Subject: Application for Permit Modification to the Section 404 Individual Permit and Section 401 Water Quality Certification for Construction of extension of NC 43 from south of NC 55 to north of US 17. Craven County. State Project No. 6.804857. TIP No. R-4463. Debit \$570 from WBS 35601.1.1.

The purpose of this letter is to request a modification to the US Army Corps of Engineers (USACE) Section 404 Individual Permit and NC Division of Water Quality (NCDWQ) Section 401 Water Quality Certification. The North Carolina Department of Transportation (NCDOT) is currently constructing the extension of NC 43 from NC 55 to US 17. The project, located west of New Bern in Craven County, is referred to as the NC 43 Connector (Bosch Boulevard) and is approximately 4.5 miles in length. A Section 404 Permit (Action ID 2007-02231-125) was issued on November 19, 2007 and Water Quality Certification issued (WQC No. 3673) on September 21, 2007. The project has been split into two sections, Section A and Section B. Section B has been let and construction has begun.

Summary of Changes

Table 1. Additional Permanent Jurisdictional Impacts for R-4463B

PROJECT REFERENCE NO. R-4463B	SHEET NO. 7
RW SHEET NO.	
ROADWAY DESIGN ENGINEER NORTH CAROLINA PROFESSIONAL SEAL 2122 MICHAEL T. MERRITT	HYDRAULICS ENGINEER NORTH CAROLINA PROFESSIONAL SEAL 18181 TIMA H. SWIEZY

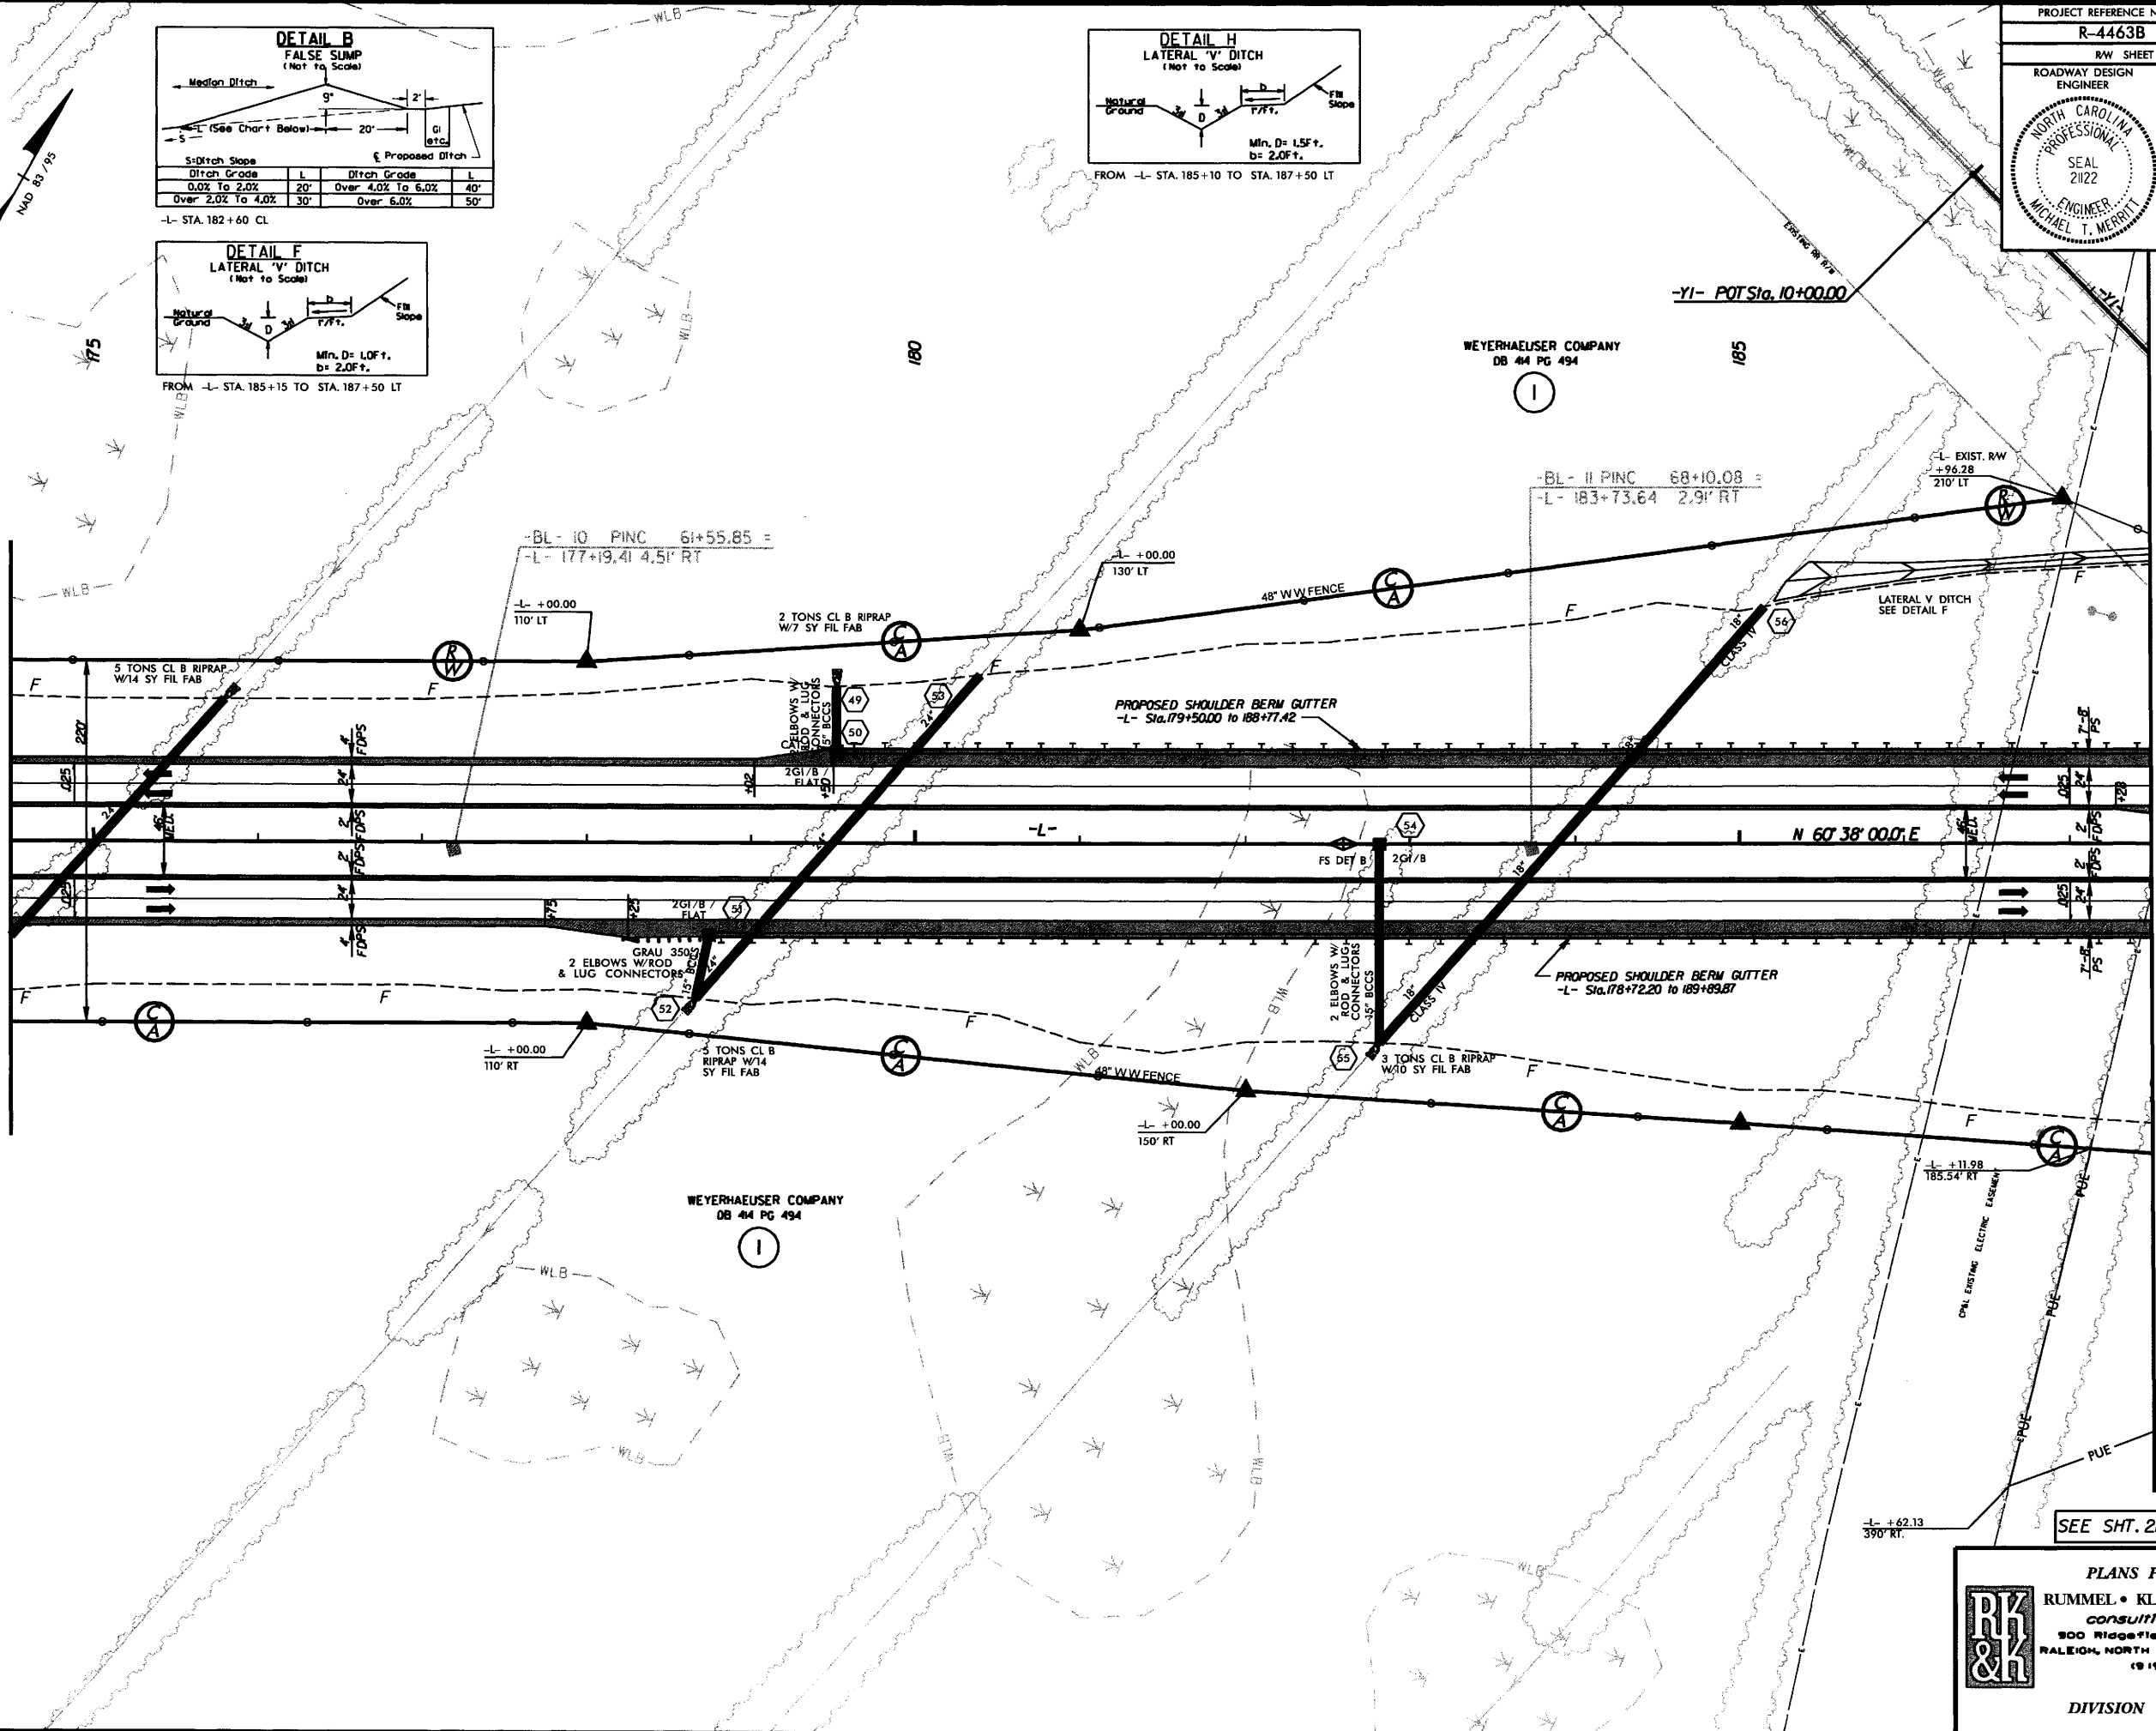
REVISIONS
Construction Revision #2, Date: ; Proposed grade revised from -L- Sta. 171+50 to 205+73.15 for new horizontal and vertical clearance criteria for the Railroad.

PROJECT REFERENCE NO. R-4463B	SHEET NO. 8
RW SHEET NO.	
ROADWAY DESIGN ENGINEER 	HYDRAULICS ENGINEER

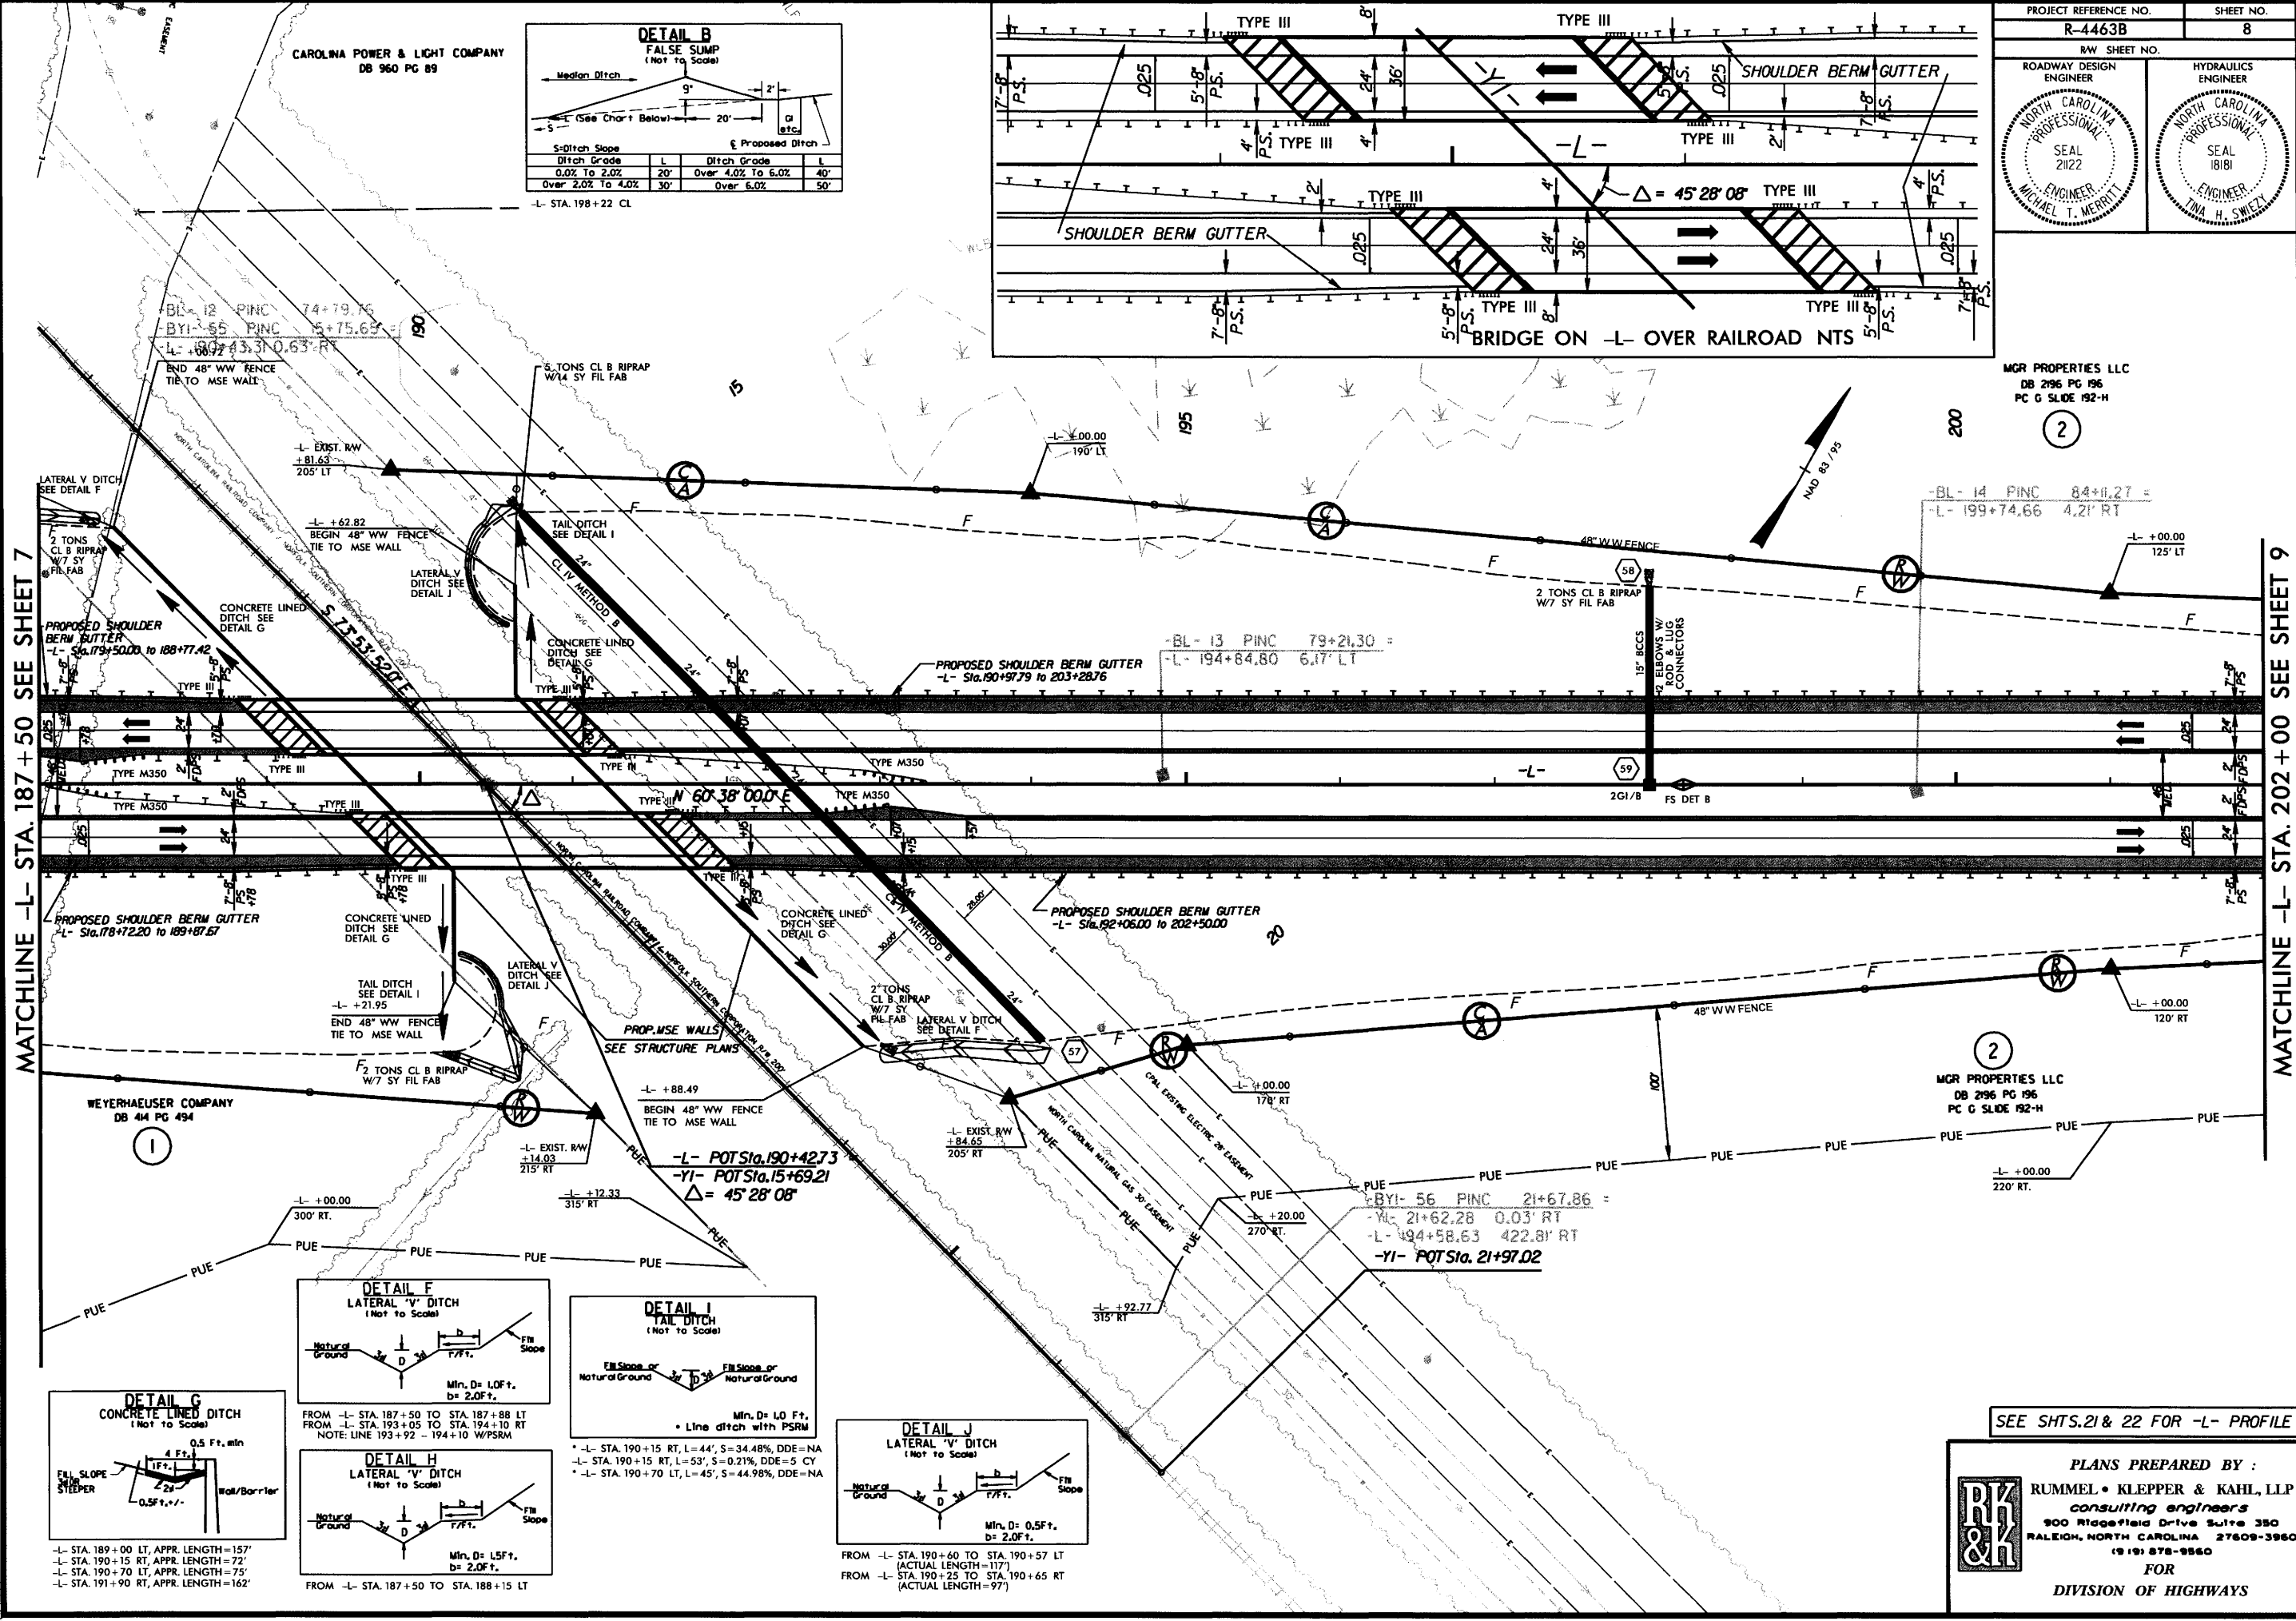
Construction Revision #2, Date: 8/17/99 Proposed grade revised from -L- Sta. 171+50 to 205+73.15 for new horizontal and vertical clearance criteria for the railroad.
